Patch-Panel-1 PCB ver.5.3

Date : 2001-11-27

Last changes :

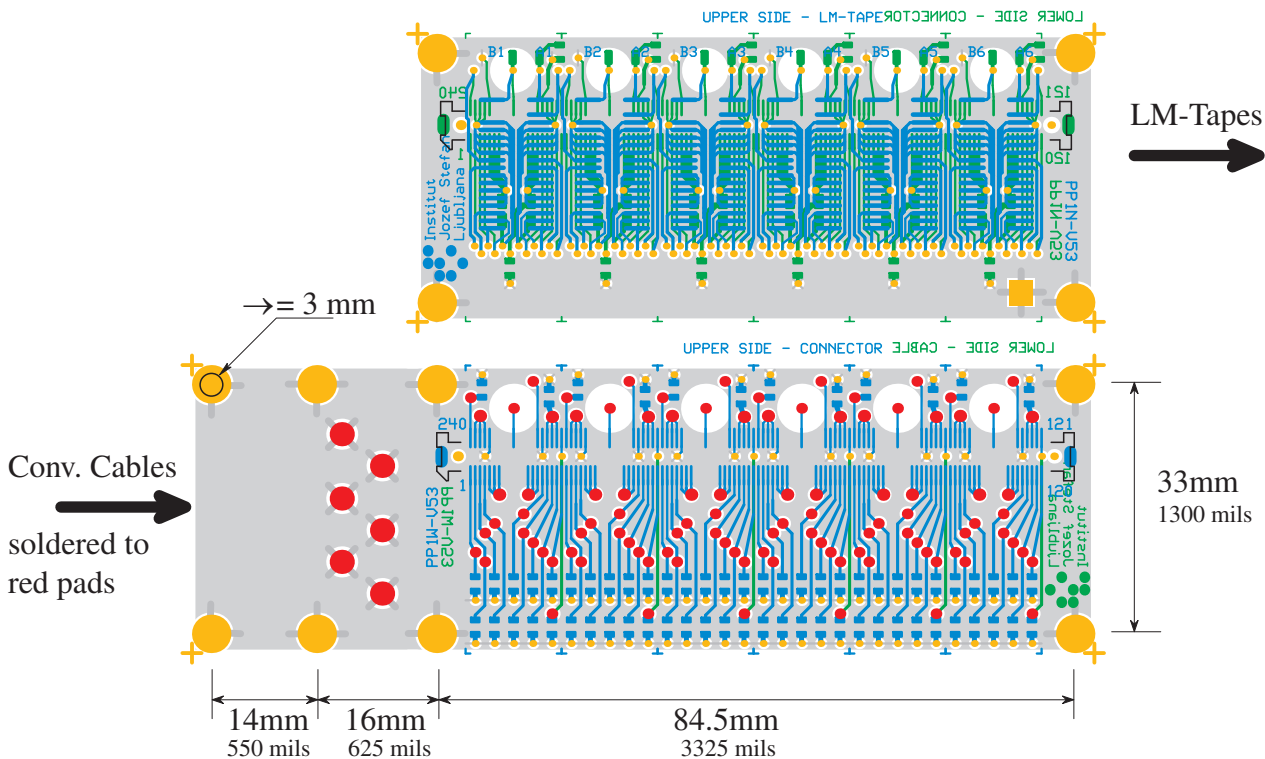
- 1) Low-Mass-Tape solder pads width : 0.6mm, length 3.5mm (already in V5.2)
- 2) Conventional Cable Clip and Shield solder pads moved from the right to the left (due to mounting orientation).
- 3) Mounting screws connected to the ground-plane (shield) layer.
- 4) Added 1 pin for Vdd and DGnd at the Molex connector (due to increased current rating of 1.3A on the digital supply).

Due to the 2.5 mm spacing of pins under the Molex connector the HV pin and the pins on the left side of it in each section had to be moved to conform with the requirement. Consequently, versions 5.x are incompatible with any other version previous to 5.
